Amended Section 75W to Stage 1 Mixed Use Development (MP10_0030)

Discovery Point, Wolli Creek

Submitted to Department of Planning and Infrastructure
On Behalf of Discovery Point Pty Ltd and Discovery Point Devt Pty Ltd

December 2012 ■ 12505

Figure 3 – Proposed revised Spark Lane (west) elevation

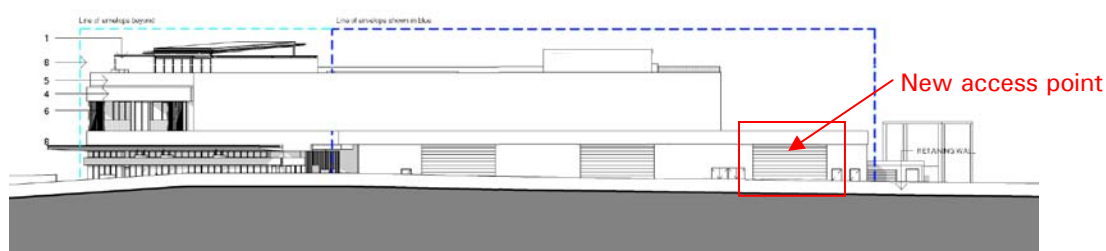
The rear of Building 1B fronting Spark Lane was approved as providing non-active ground floor uses (loading dock, residential waste room, services etc) consistent with the Development Design Guidelines (clause 9.3.1). This approach to the rear of Building 1B will remain, with the introduction of an additional/third vehicle access point along the ground floor elevation and the removal of the waste room access door.

Overall, the proposed introduction of an additional vehicle access point along the rear ground floor elevation ground of Building 1B will have no material impact on the building's appearance (in context with the existing service lane character – refer to **Figure 3**).

Figure 5 – Proposed amended Building 1B rooftop

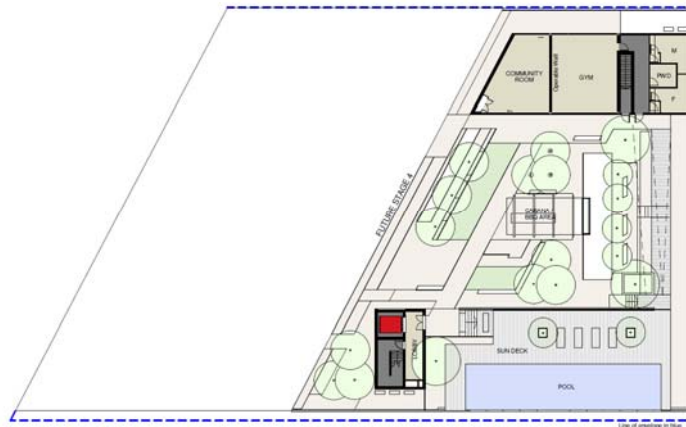
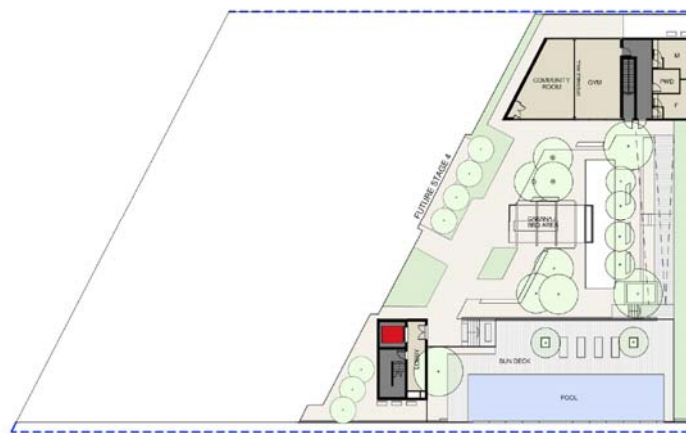
Following the approval of Stage 1 in March 2012, Building 4 has since undergone design development with a development application lodged in November 2012. With the details and relationship of how Building 4 and Building 1B will interact, it has become evident that in order to the proposed Building 4 terraces, a minor adjustment to the area and design of the communal rooftop is required. Most notably, the relatively minor protrusion of the Building 4 terraces results in a minor adjustment to the area of the communal rooftop (by approximately 88m²) and a reduction in the length of the community room/gym building.

Importantly, the proposed changes in reducing the stage 1 boundary at this level along with the associated reduction in the area of the communal rooftop will not affect the range or quality of facilities to be provided (as evident in comparing the proposed amended Building 1B rooftop – refer to **Figure 5**).
